ECN - Tekniskt ändringsmeddelande

ECN-S04838

UPPDATERING ELBROMS REAL 9000 PLUS

UPDATE OF THE ELECTRIC BRAKE REAL 9000 PLUS

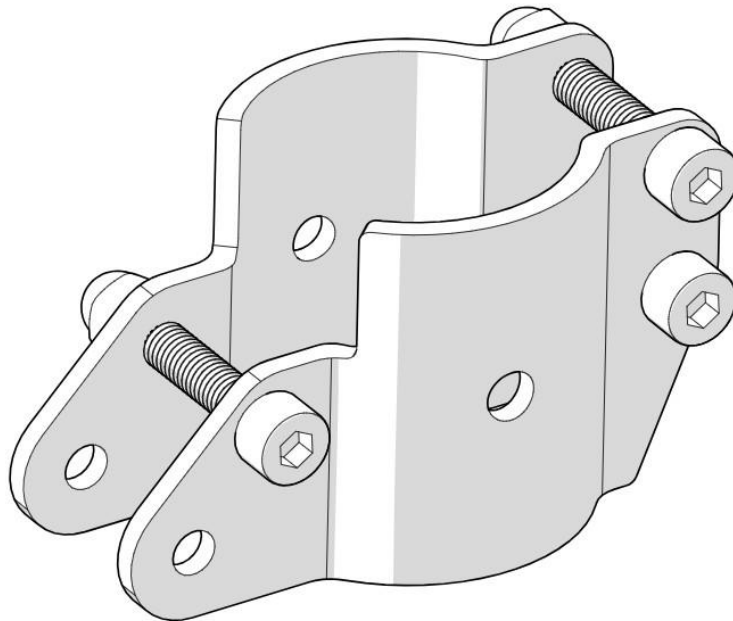
Elbroms Centrumfäste 9000f Eldon till REAL 9000 Plus har reviderats för enklare montering.

Denna artikel har varit onödigt knepig att både tillverka och montera historiskt. Detta på grund av svetsmuttrarna som inte alltid satt rakt samt att formen på bockningen varit svår att få lika.

- Tillverkningsprocessen är ändrad till pressning i stället för kantpress.
- Svetsmuttrarna är ändrade till gängor och hattmuttrar.
- Tjockleken på plåten är ändrad från 3 till 4 mm.

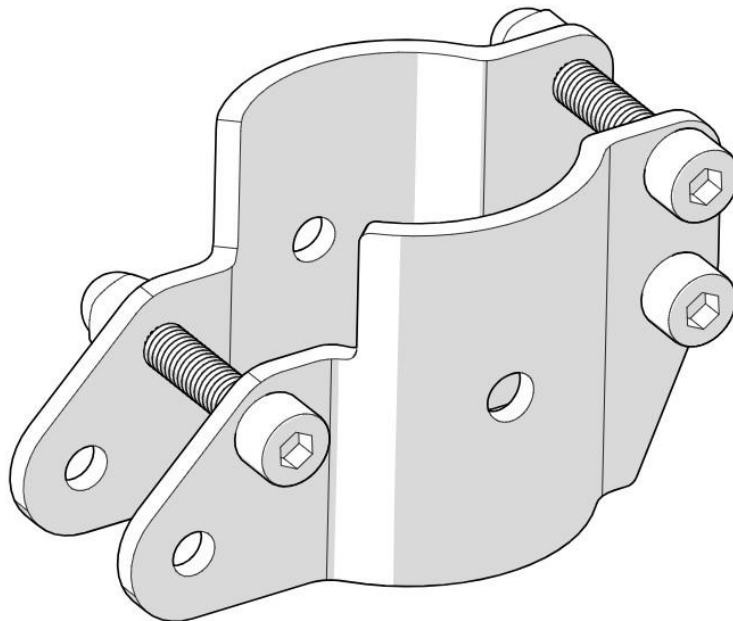
El. brake Centre attachment 9000 f electric kit for REAL 9000 Plus has been revised for easier assembly.

This item has historically been unnecessarily tricky to both produce and assemble. This is due to the weld nuts not always being properly aligned and the shape of the bending being difficult to make consistent.

- The manufacturing process has been changed to pressing instead of using a press brake.
- The weld nuts have been replaced with threads and cap nuts.
- The sheet metal thickness has been changed from 3 to 4 mm.
